SUNDRY NOTICES AND REPORTS ON WELLS
Do not use this form for proposals to drill or to re-enter an abandoned well. Use Form 3160-3 (APD) for such proposals.

8. Well Name and No. Federal B # 2 ✓

9. API Well No. 30-025-11588

**Permanent Abandonment of Federal Wells
Conditions of Approval**

Well Name: Federal B #2

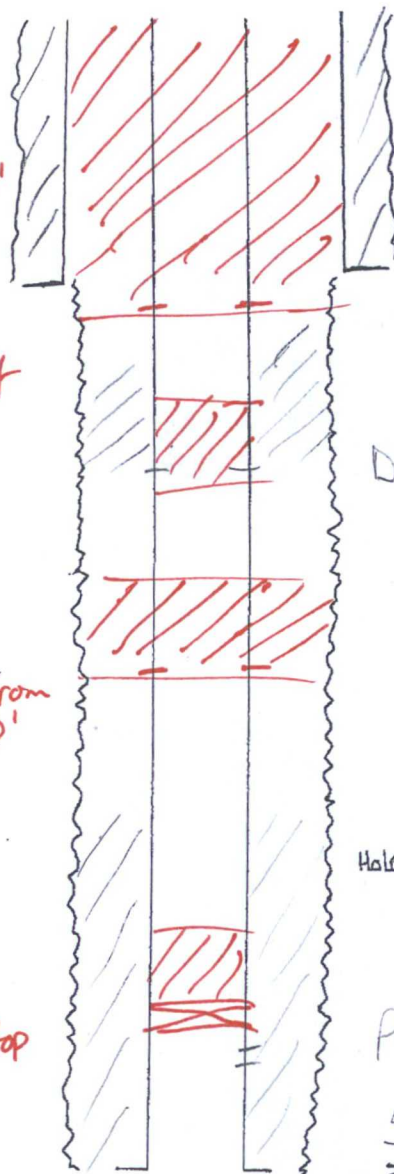
Perf + sqz cmt
from 350' to 0'

Spot 30 sx cmt
from 1050-800'
Tag

Perf + sqz
30 sx cmt from
2280 - 2150'
Tag

Set GIBP
@ 3100' w/
25 sx cmt on top
